ADDENDUM NO. 2

TO: PLANS AND SPECIFICATIONS FOR STATE OF MISSOURI

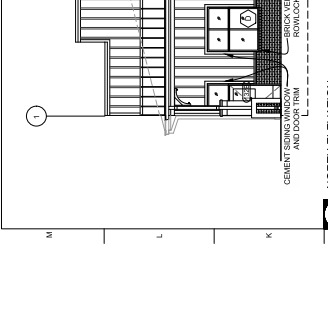
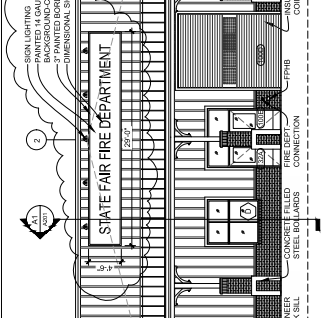
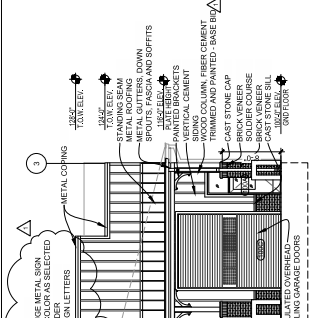
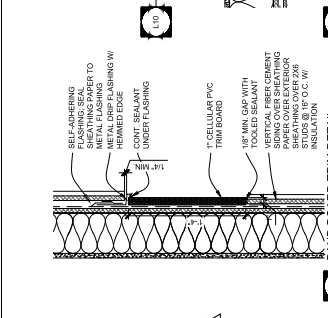
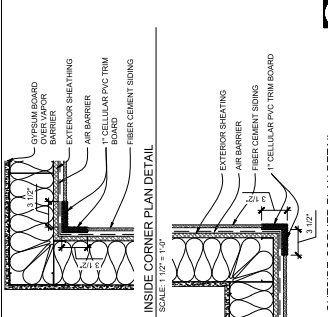
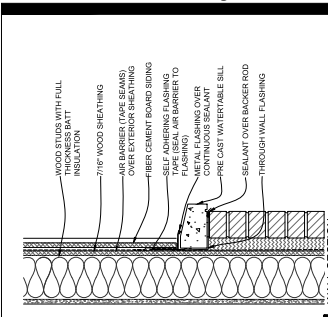
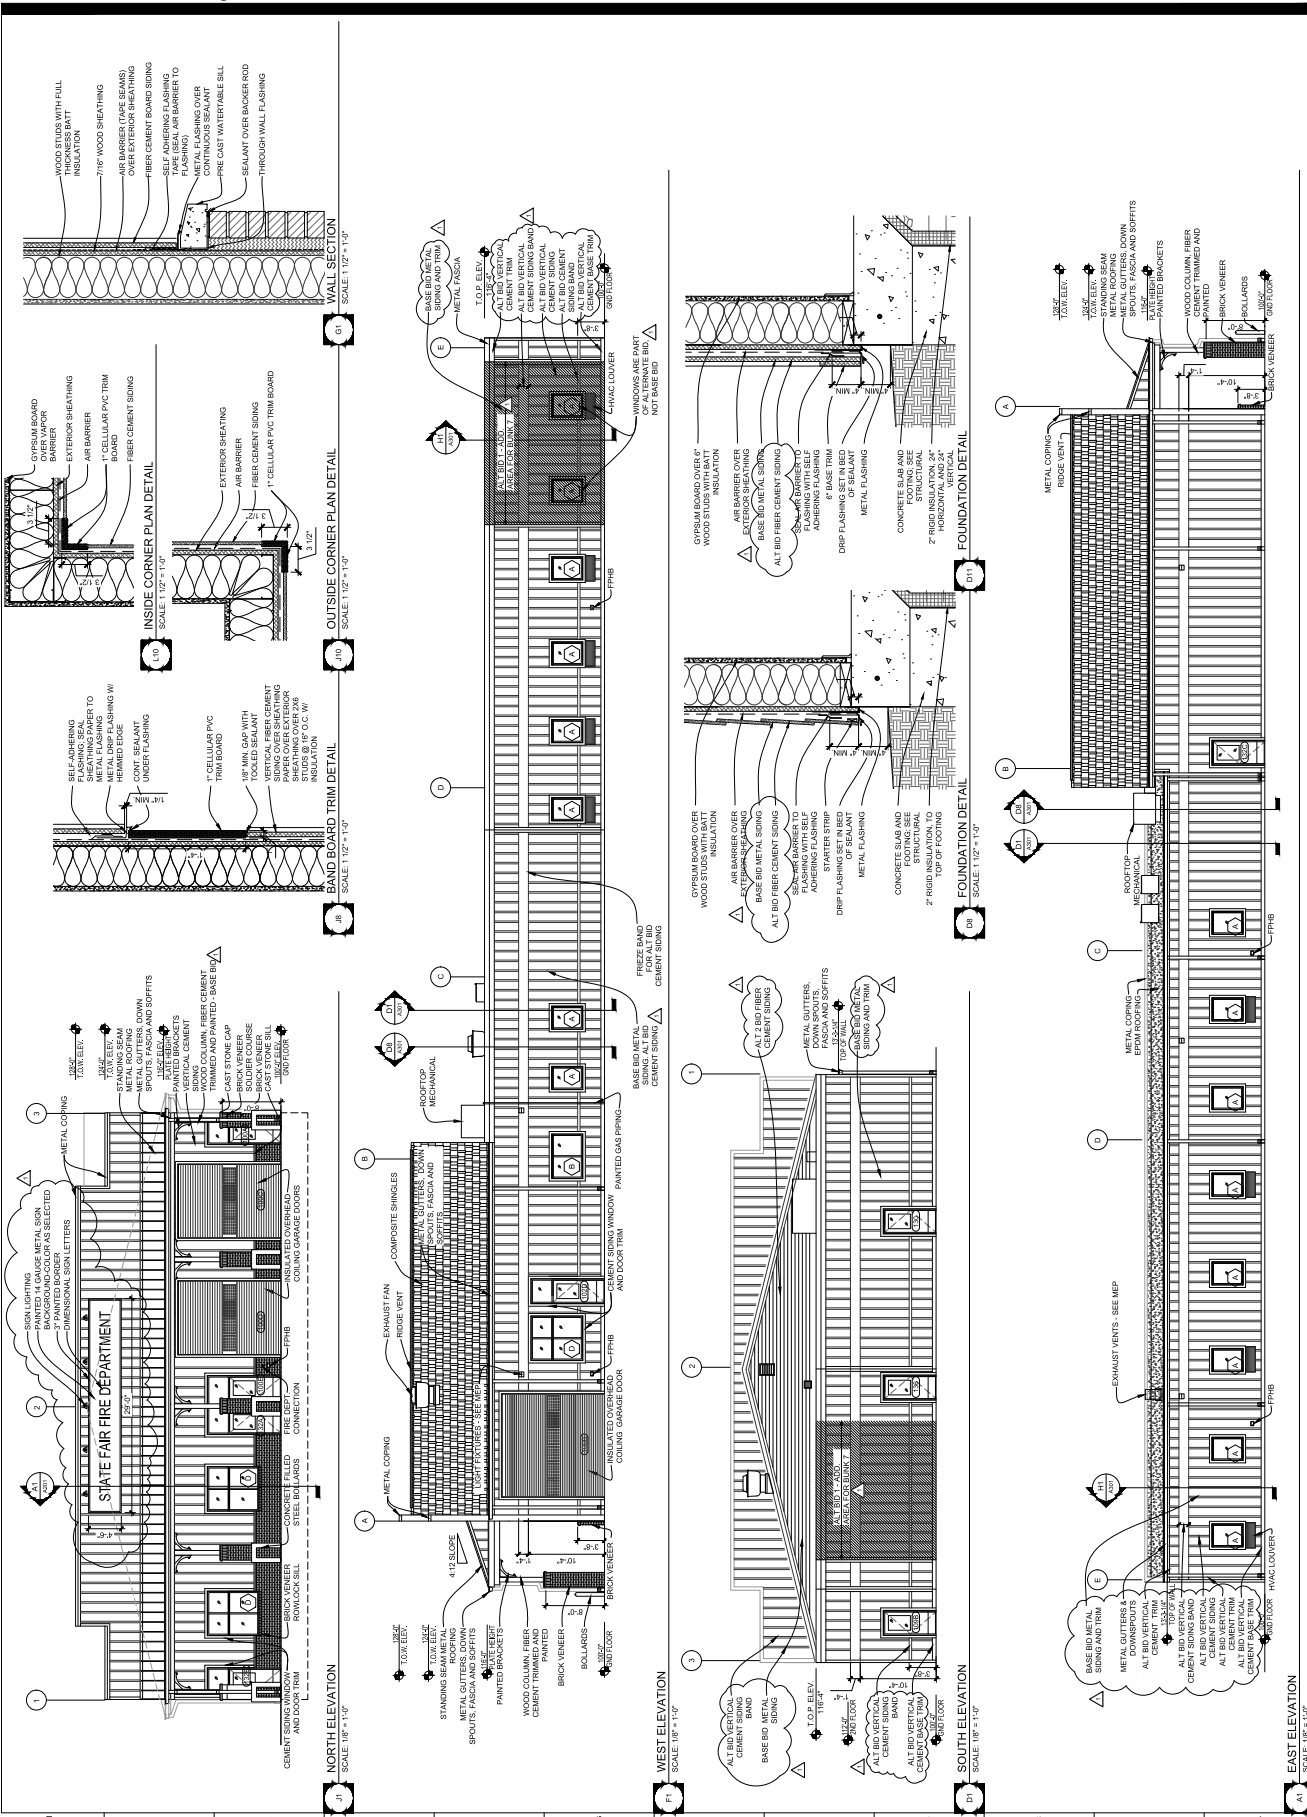
1. MEASURE ALL DIMENSIONS AND CONDITIONS PRIOR TO EXECUTING ANY WORK. VERIFY EXISTING CONDITIONS AND WORK OFFERING FROM THAT SHOWN FOR CLARIFICATION BY THE ARCHITECT PRIOR TO PROCEEDING WITH CONSTRUCTION.
2. VERIFY ALL SOLID OPENINGS FOR DOORS, WINDOWS, EQUIPMENT & OTHER "HULL IN" ITEMS PRIOR TO THE EXECUTION OF ANY WORK AFFECTED BY SAME.

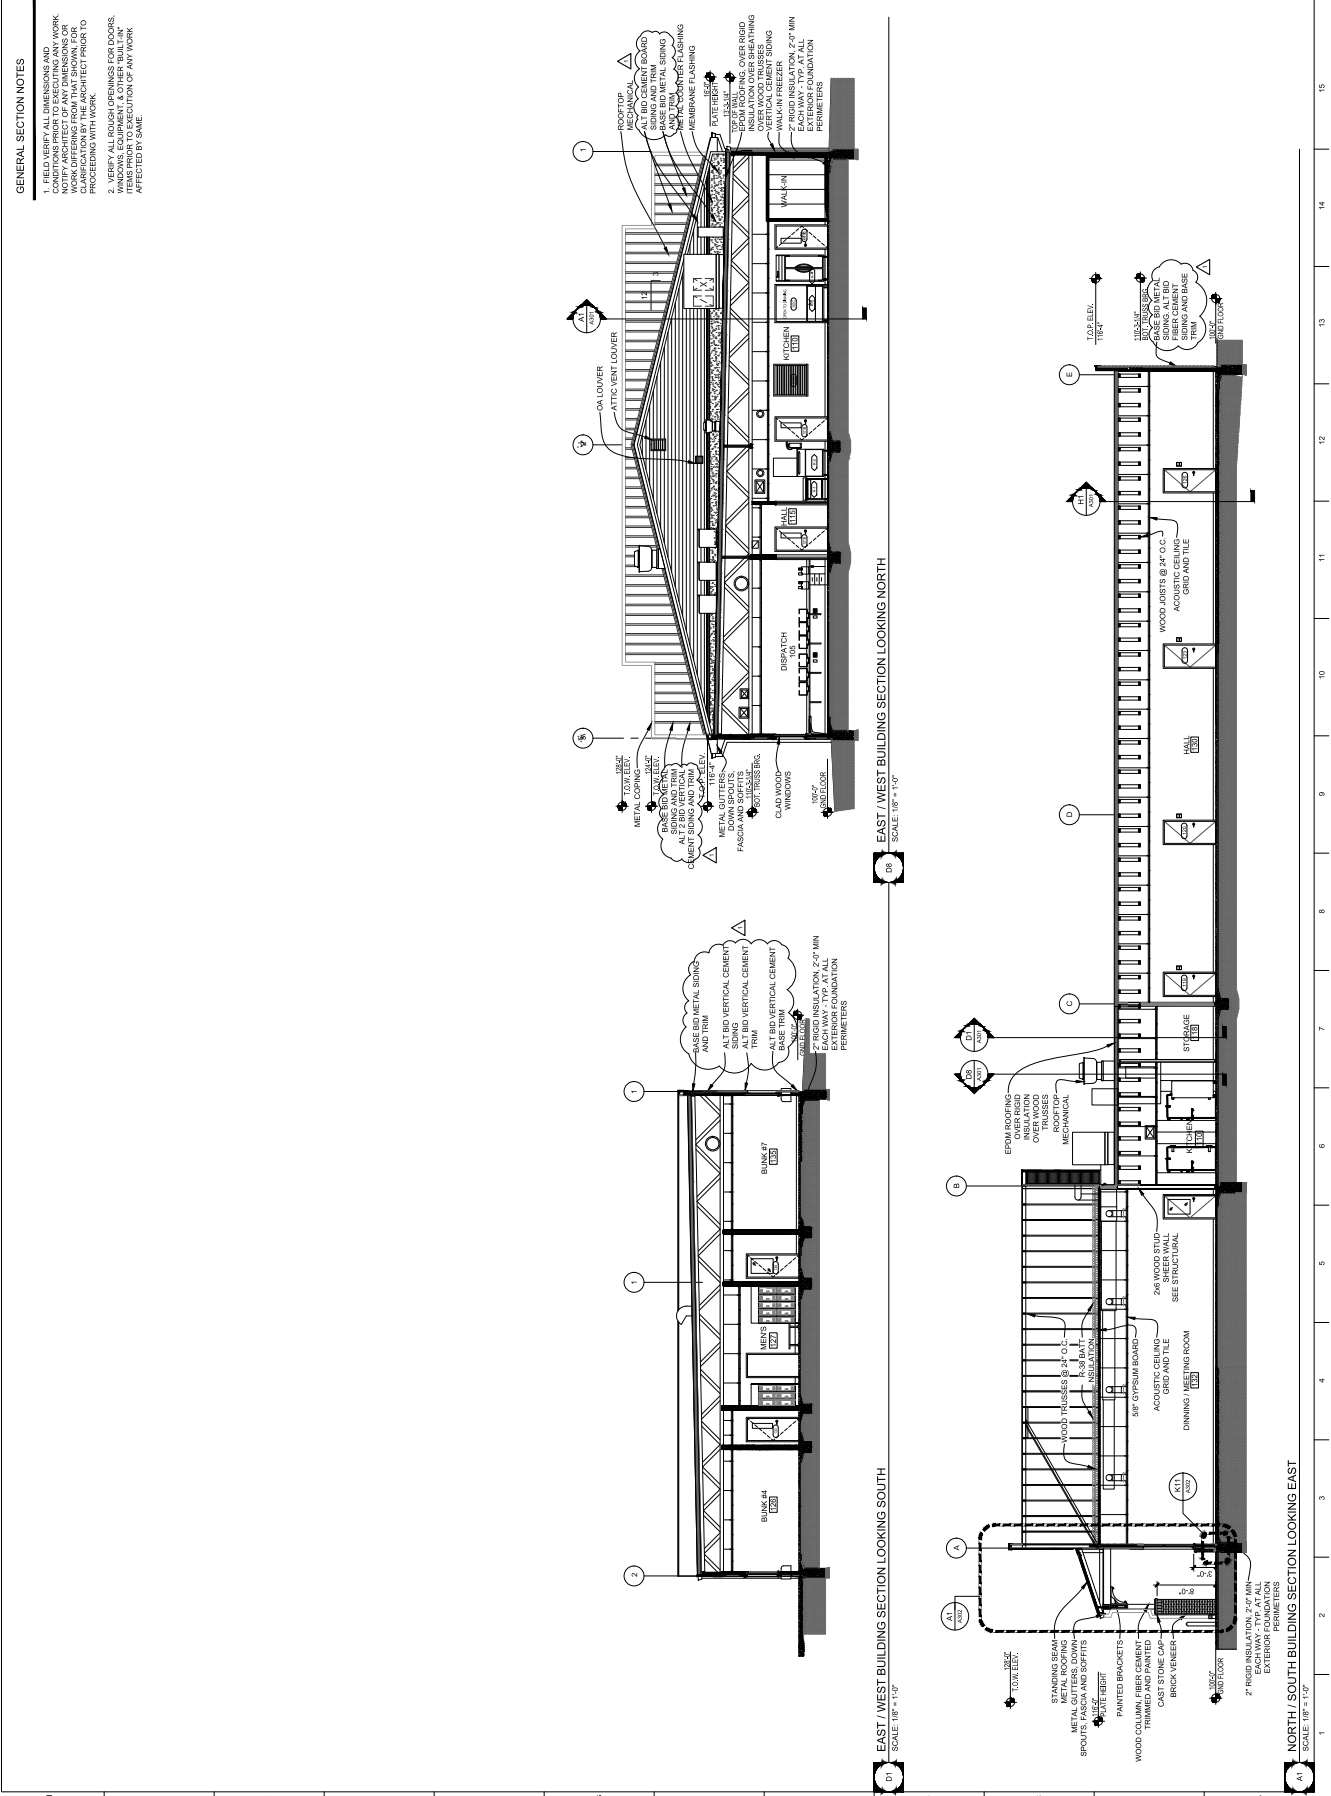
REVISION: ADDENDUM J
REVISION: JULIE 2024
DATE: 09/19/2025
